Technical Service Bulletin

Technical Service Bulletin: tsb101016	Released Date: 03-Dec-2009
Optimized Lubricating Oil Filter

Optimized Lubricating Oil Filter

07c00651

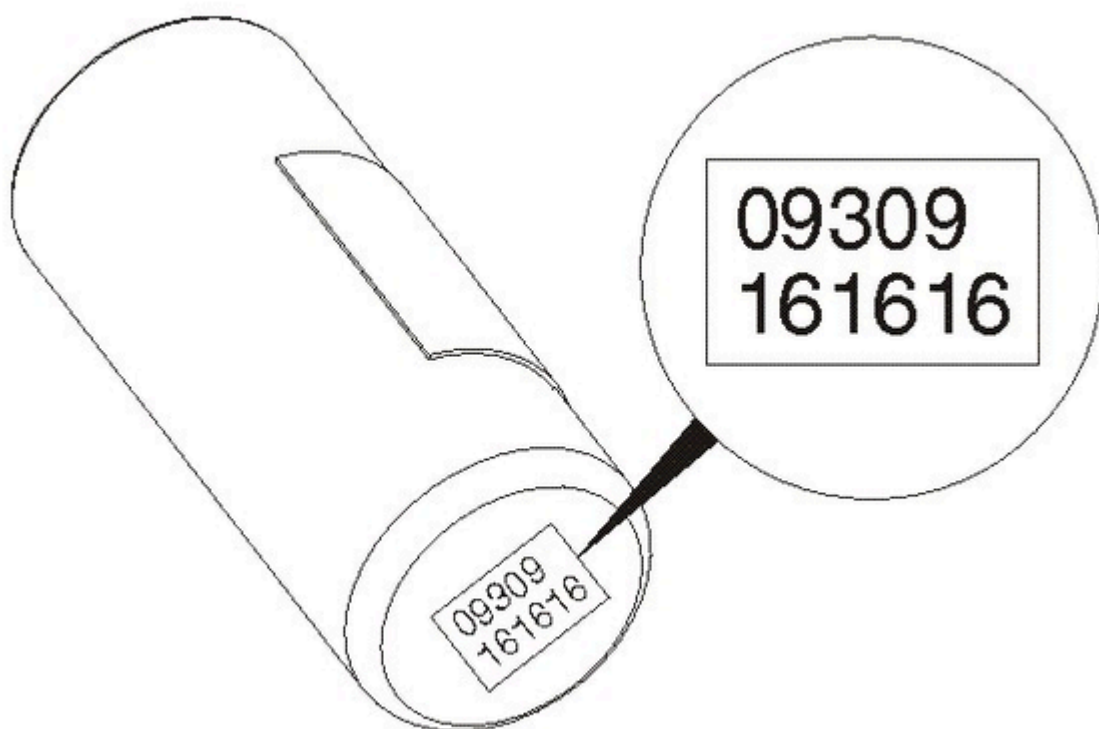
Optimized LF9000 and LF9001 filters were manufactured beginning November 5, 2009. The filters will display a date code – inkjet printed on the bottom of the filter – in the format shown in the photograph in the Repair Instruction section.

The top line reflects the filter manufacturing code. Filters with the modification will read: 09309 and higher. The products could also reflect code 10001 and higher. The bottom line of the filter code is **not** necessary for filter identification in this instance.
